## SELLINDGE PARISH COUNCIL

Y16/0068/SH

Otterpool Quarry, A20, Sellindge.

Retrospective planning application for change of use of a former quarry site to a temporary secure 24-hour lorry park with associated facilities for a period of 24 months.

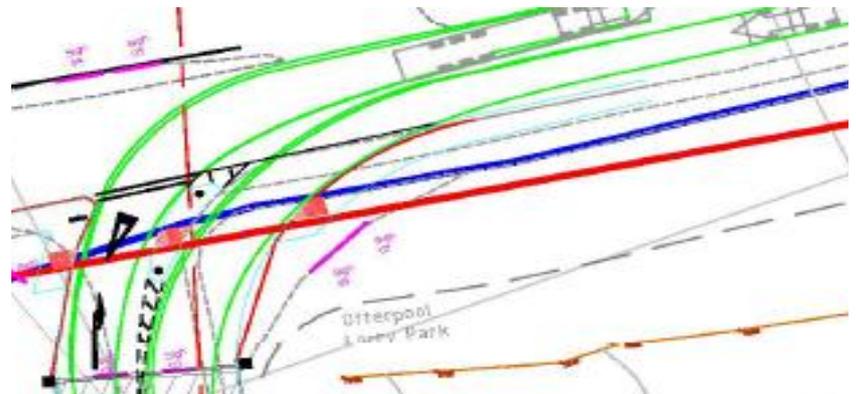
26 The access **IS DETRIMENTAL** to other road users and pedestrians, due to -

- A The amount of mud that is spread across the road, after rain, which could well be contaminated.
- B The amount of dust across the road and in the air when the weather is hot and sunny, which again may well be contaminated.
- C The common practice of lorries using the Airport Café, to go into the Otterpool quarry site, where they drive straight across the A20.
- D The common practice, of coming up behind 2 or 3 lorries parked on the A20, waiting to gain access to the Otterpool quarry site.
- E The common practice of lorries reversing up the A20, when they have missed the site access, when coming from either directions.
- F The common practice of lorries using the Otterpool / A20 traffic light controlled junction to perform a U turn, when they have missed the site access, coming from the Ashford direction
- G The poor pedestrian links either side of the Otterpool Quarry site.
